RELIANCE DRESSES LIMITED

12 October 2025

2. Observation:

Observation-07: Lack of as-built drawing. (Dining Shed, Child Care Shed, Wastage Shed, Security Shed, Boiler Shed, Fire Hydrant Shed, Car Parking)

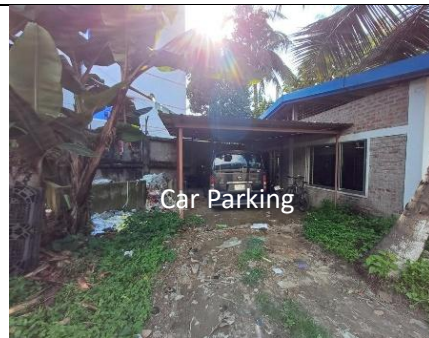
Description: As-built drawings were not found for these structures. Building engineer is required to prepare as-built drawings with complete structural & architectural details.

12.	Lack of as-built drawing. (Dining Shed)	Building engineer is required to prepare as-built drawings with complete structural & architectural details.	within 6 weeks

Observation-09: Inadequate connection and lack of stability. (Child Care Shed, Security Shed, Fire Hydrant Shed, Car Parking)

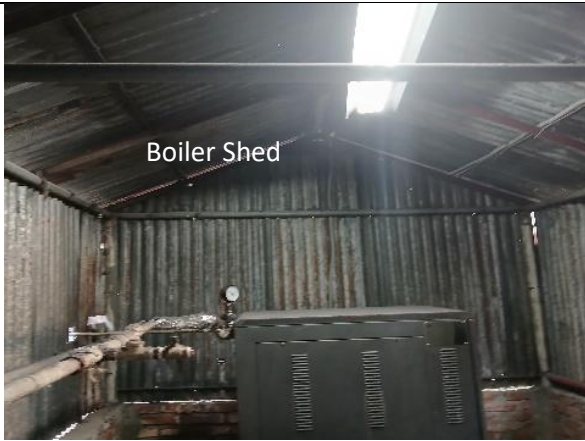
Description: Poor connection details were observed on the sheds. A safety check report according to the Accord Building Standard is required to be prepared to check the inadequacies. Or replace the existing structure with an engineering one where necessary.

16.	Inadequate connection and lack of stability. (Child Care Shed)	A safety check report according to the Accord Building Standard is required to be prepared to check the inadequacies.	within 6 weeks

Observation-10: Inadequate member size, connection, and lack of stability. (Wastage Shed, Boiler Shed)

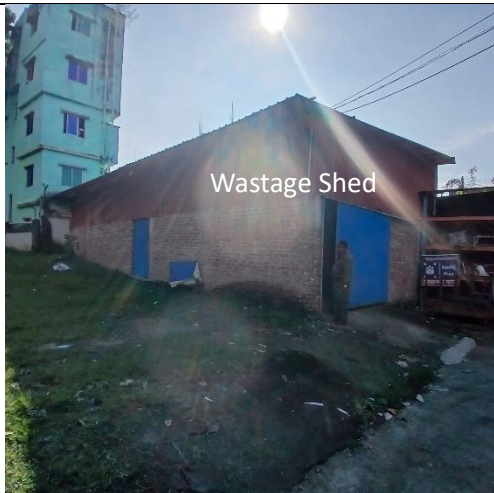
Description: Inadequate member sizes, poor connection details were observed on these sheds. Building engineer is required to check the connection adequacy and lateral stability as a part of EA. Or replace the existing structure with an engineering structure.

19.	Inadequate member size, connection, and lack of stability. (Wastage Shed)	Building engineer is required to check the connection adequacy and lateral stability as a part of the EA.	within 6 weeks
